Stormwater Review by: Ghassan Aouad
Phone: 480-312-7055
e-mail: gaouad@scottsdaleaz.gov

Case #: 39-DR-2024
Review Cycle: 1
Date: 02/19/2025
Status: Corrections Required

DRAINAGE DESIGN REPORT MAIN & MARSHALL REMODEL

PROJ NO. 644-PA-2024 KEY CODE 24029

VICINITY MAP

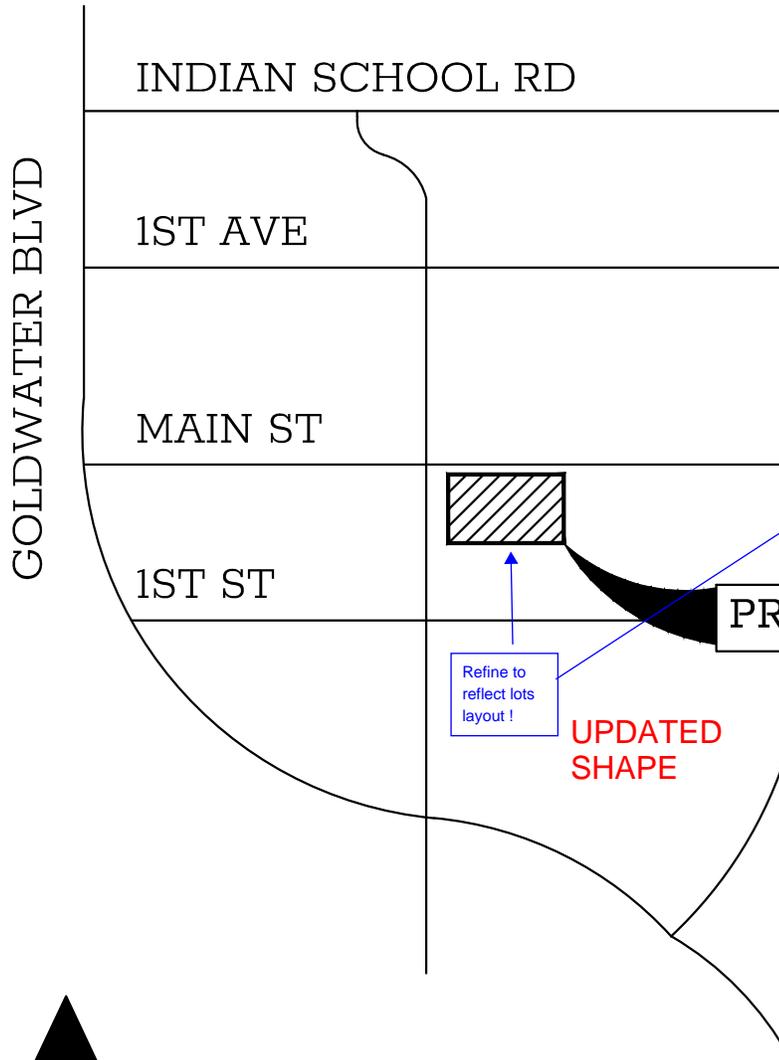
image from the city database, which not guaranteed to be 100% accurate

Refine to reflect lots layout!

UPDATED SHAPE
